**DECISION No 30/2020
OF THE EUROPEAN UNION AGENCY
FOR THE COOPERATION OF ENERGY REGULATORS**

**ON THE CORE CCR TSO's PROPOSAL FOR THE METHODOLOGY FOR
COST SHARING OF REDISPATCHING AND COUNTERTRADING**

Figure 1: The difference between two considered options for priorities of flows

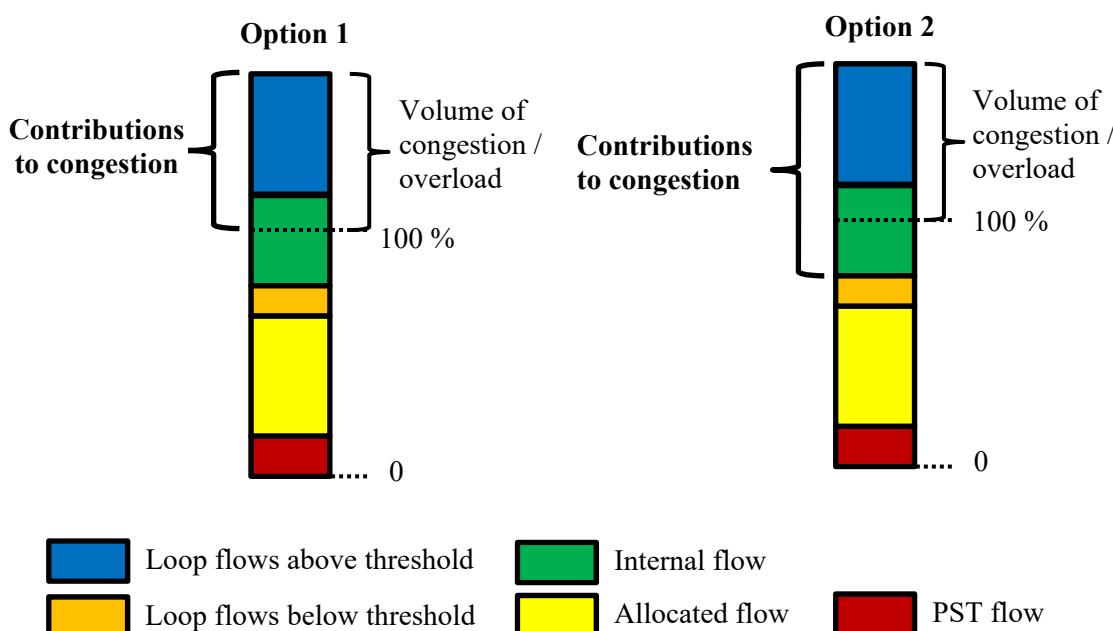
- (128) Option 1 and 2 are presented in the figure below, which shows the stacking of different flow components in relation to the maximum capacity of the network element (denoted with 100%). In Option 1 of this example all loop flows are identified as contributors to congestion, whereas only the internal flow which is needed to cover the remaining congestion is identified as contributor to congestion. In Option 2, all loop flows and the whole internal flow are identified as contributors to congestion, however, since their sum is larger than the volume of congestion they are scaled down afterwards to become equal to the volume of congestion (i.e. volume of overload). This scaling does not change the relative shares of loop flows and the internal flow.

- (129) ACER carefully evaluated different arguments from Core TSOs and regulatory authorities, analysed possible options and performed the simulations of investigated options based on the data used in the Experimentation report. While ACER recognises some validity of arguments of both groups of Core TSOs and regulatory authorities, it considers that the arguments of the majority of TSOs and regulatory authorities are stronger in this specific case.
